Technical change to PROFINET cord sets with RJ45 connector

Change of the RJ45 connector

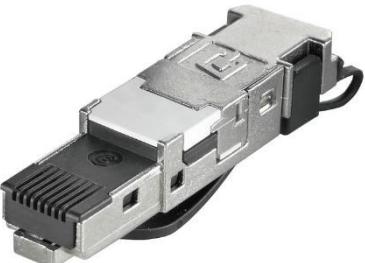
Within the articles listed under point 4, a universal RJ45 connector has been used so far. The new connector is specially designed for PROFINET use.

The insulating body of the previously used RJ45 connector was black.

A green insulating body is used for the new RJ45 connector.

The technical specifications such as dimensions, electrical properties and connection cross-sections remain identical.

Currently used connector	New incoming connector
WM Art. Nr. 1963600000 	WM Art. Nr. 1132060000
